# Access Compliance Report

## Public Rights-of-Way

### (Curb Ramps)

Intersection ID: 44913		Main Street: SPRINGHAVEN_DR		Cross Street: OAK_DR		Location: NE			
ADA ID: FA07730B7675		Ramp Type: PerpDiag		Initial Pass/Fail: Fail		Overall Compliance: No		Severity Score: 10	
Codes/Mitigation Info/Possible Solution				Field Measurements/Component Compliance

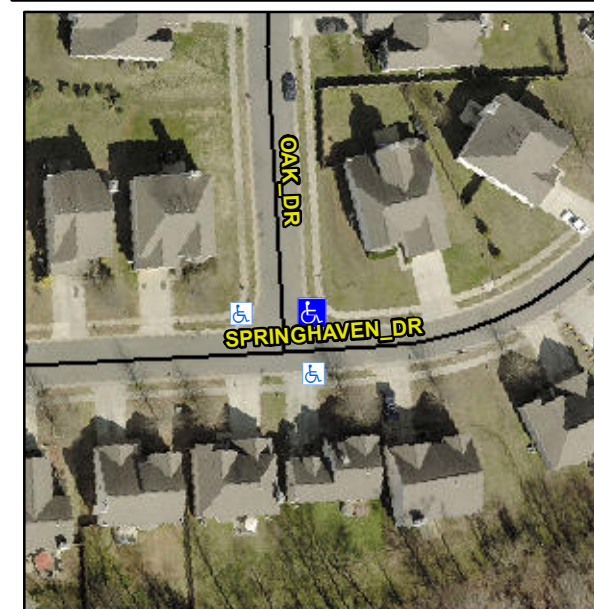
**Not Found, R304.5.1, R304.5.3**

Compliance	Description	Data	Compliance	Description	Data
N/A	Ramp Length (in)	47.0	Yes	Ramp Slope (%)	7.9
No	Ramp Width (in)	39.5	No	Ramp XSlope (%)	3.0
N/A	Flare Type LT	N/A	N/A	Flare Type RT	N/A
N/A	Flare Slope LT (%)	N/A	N/A	Flare Slope RT (%)	N/A
N/A	Flare Traversable LT?	N/A	N/A	Flare Traversable RT?	N/A
N/A	Landing Length (in)	N/A	N/A	DWS Provided?	N/A
N/A	Landing Width (in)	N/A	N/A	DWS Contrast?	N/A
N/A	Landing Slope (%)	N/A	N/A	DWS Length (in)	N/A
N/A	Landing X Slope (%)	N/A	N/A	DWS Full Width?	N/A
N/A	Landing Curb? (Y/N)	N/A	N/A	DWS Offset (in)	N/A
N/A	Shared Landing?	N/A			
N/A	Gutter Ponding?	N/A	N/A	Gutter Slope (%)	N/A
N/A	Gutter Lip Ht (in)	N/A	N/A	Gutter X Slope (%)	N/A
N/A	Painted X Walk1?	No	N/A	Painted X Walk2?	No
	X Walk 1 Direction	To W		X Walk 2 Direction	To S
N/A	X Walk 1 Width (in)	N/A	N/A	X Walk 2 Width (in)	N/A
	X Walk 1 Slope (%)	3.5		X Walk 2 Slope (%)	0.2
	X Walk 1 X Slope (%)	1.6		X Walk 2 X Slope (%)	1.9

**Remove & Replace Curb Ramp With Two New Directional Ramps or Equivalent.**
